Clause 104 Maintenance Requests

Overview

Table 104-5—Valid PD detection signature characteristics, measured at PD PI

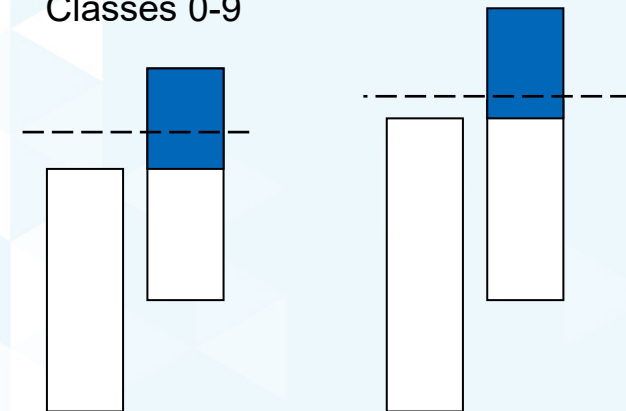
Transitions from DO_CLASSIFICATION to MDI_POWER1 pragmatically occur between V_{PUP,max} and V_{sig_disable,max}. In 802.3bu, for Classes 0-9, this decision region spans 0.75V. In 802.3cg, for Classes 10-15, V_{PUP} changed to 5.5V, without a corresponding change to V_{sig_disable}. The resulting decision region is reduced to 0.25V.

Modify 104-5 as follows, splitting V_{sig_disable} into two rows

Parameter	Conditions	Min	Max	Unit
V _{good}	7mA < I _{PD} < 17mA, PD exiting RESET state	4.05	4.55	V
I _{signature_limit}	V _{PD} < V _{sig_disable} max	—	24	mA
V _{sig_disable, Classes 0 to 9}	V _{PD} rising	4.6	5.75	V
V _{sig_disable, Classes 10 to 15}	V _{PD} rising	6.0	7.5	V
V _{sig_enable}	V _{PD} falling	3.6	4.3	V

Technical, 802.3bu, Page 53, Figure 104-8

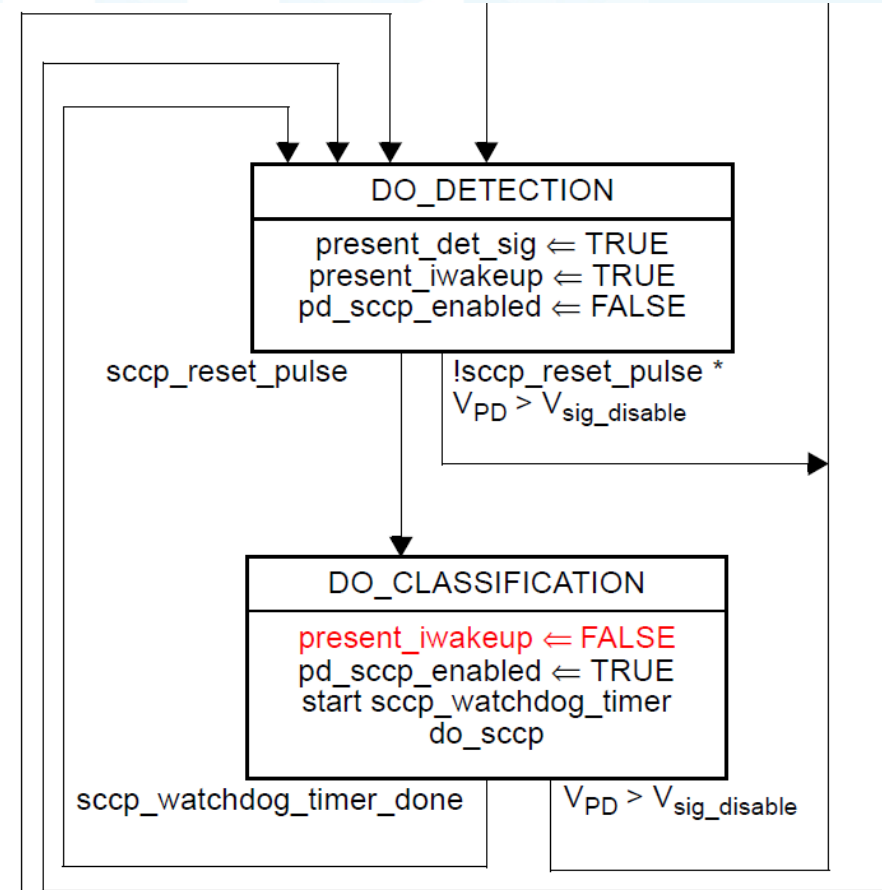
The PD state machine, as written, requires present_iwakeup to be TRUE in DO_CLASSIFICATION based on an assignment derived from DO_DETECTION. During classification the PD is engaged in SCCP signaling and cannot simultaneously present the iwakeup signature.

Modify Figure 104-8 as follows, specifically setting present_iwakeup to FALSE in DO_CLASSIFICATION.
